PROJECT NO. 35077

**FIRST AMENDMENT TO THE**  
**INTERCONNECTION AGREEMENT**  
**BETWEEN**  
**CROSS TEXAS TRANSMISSION, LLC**  
**AND**  
**PATTERN PANHANDLE WIND 3 LLC**

**FIRST AMENDMENT TO THE  
ERCOT STANDARD GENERATION INTERCONNECTION AGREEMENT**

# **EXHIBIT "C-1"** **CONCEPTUAL ONE-LINE OF INTERCONNECTION FACILITIES**

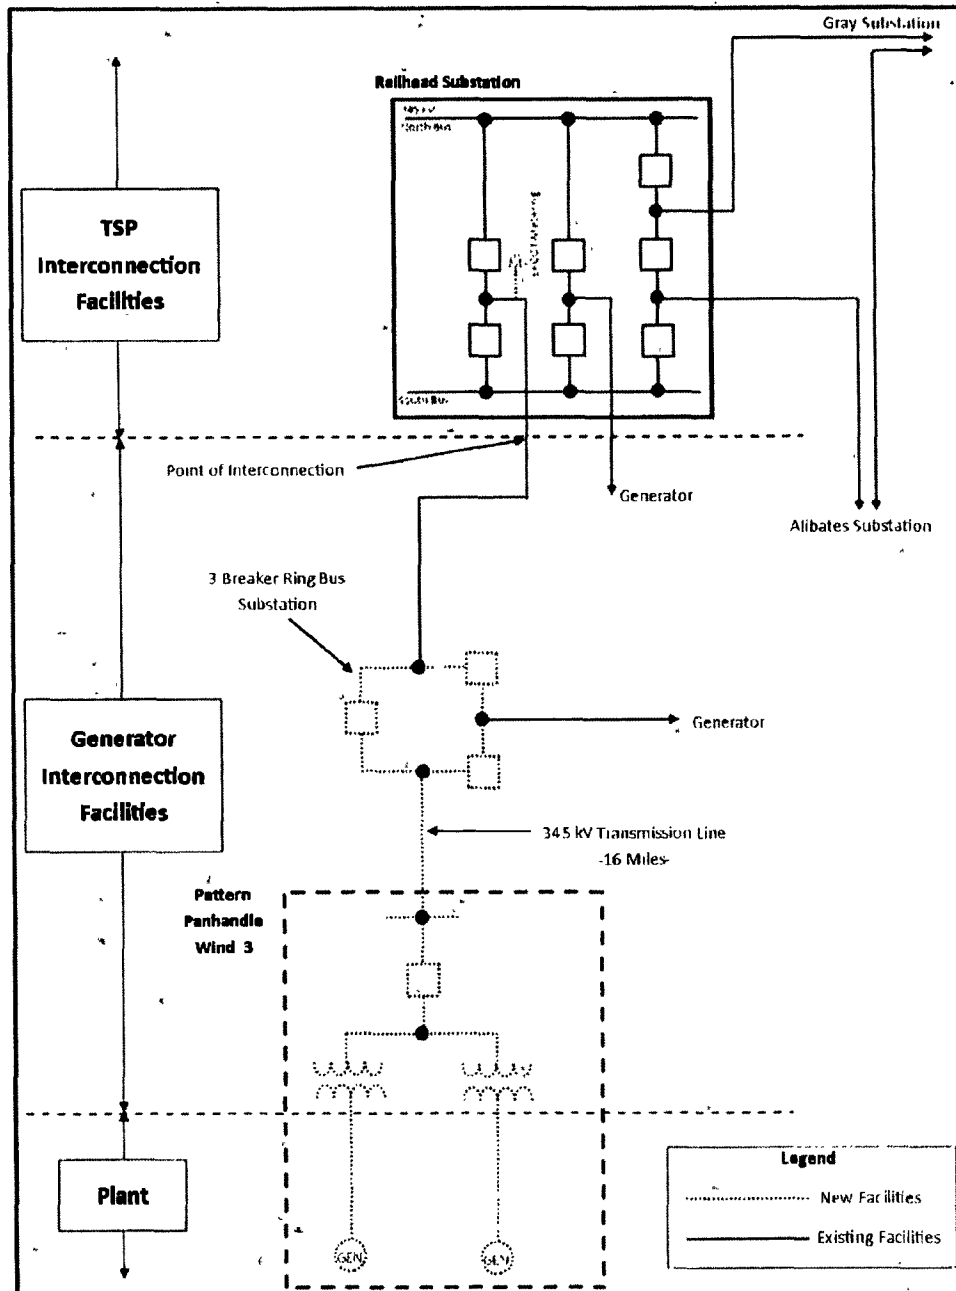
3. Exhibit "C-1" of the Agreement is hereby replaced in its entirety with the Exhibit "C-1" attached to this First Amendment.
4. Exhibit "D" of the Agreement is hereby replaced in its entirety with the Exhibit "D" attached to this First Amendment.
